Arborist Comments Report

Prepared For: 5 Point Projects

11-23 Macarthur Avenue

9				
Project Name	ject Name Review of Proposed Development				
Project Arborist	Roger Rankine (AQF Level 8)				
Client	5 Point Projects				
Address	11-23 Macarthur Avenue, Hamilton QLD 4007				
IAS Reference	IAS19092				
Prepared By	Roger Rankine (AQF Level 8)				
Checked By	Mick Maher (AQF Level 5) Date Friday, 15 August 2025				
Revision	1				
Andrew Rankine Director	 Diploma Arb. (AQF Level 5) Arboriculture Australia Registered Professional Arborist QTRA (Qualified) TRAQ (Qualified) ISA Certified Arborist & Municipal Specialist AU-0269AM QAA Qualified Member 				
Roger Rankine Managing Director	 Diploma Arb. (AQF Level 5) Grad Cert Arb. (AQF Level 8) ISA Board Certified Master Arborist (QL-001A) QTRA (Qualified) TRAQ (Qualified) QAA Qualified Member 				
Mick Maher Business Manager	 Diploma Arb. (AQF Level 5) TRAQ (Qualified) QTRA (Qualified) Cert II Horticulture (Turf Management) Cert IV Project Management QAA Qualified Member

DA301 BUILDING SECTION B

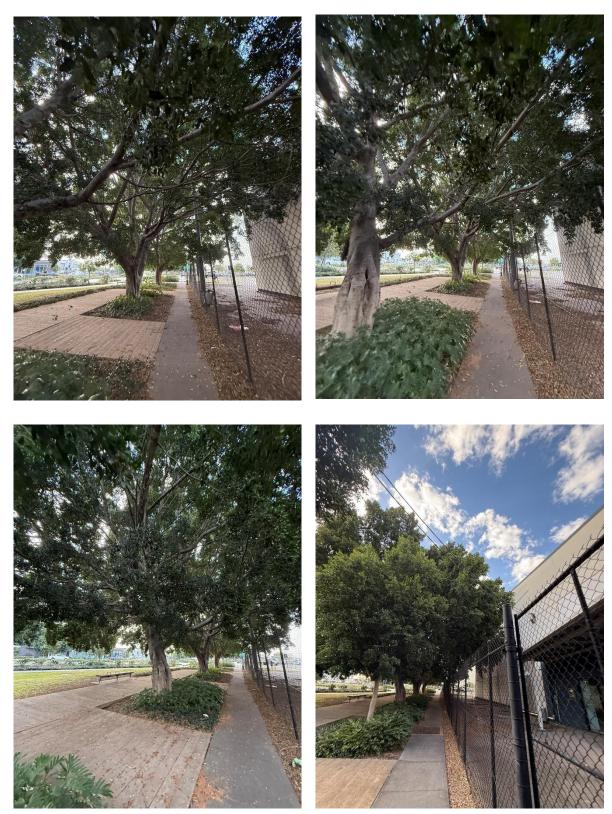
Tree Location Planter surrounds on all retained trees to be maintained as per the current surrounds **DA100** -3 X EXISTING CROSSOVERS TO BE REMOVED (SHOWN RED DASHED) FLOOR PLAN - GROUND LEVEL MACARTHUR AVENUE REET ACCESS LANEWAY ST (A) DDA TURNAROUND CLEARANCE PEDESTRIAN SIGHT TRIANGLE TO BE KEPT CLEAR OF ALOLO OBSTRUCTIONS TO VISIBILITY. LOW HEIGHT PLANING TO 500mm PERMITTED. **(**B)
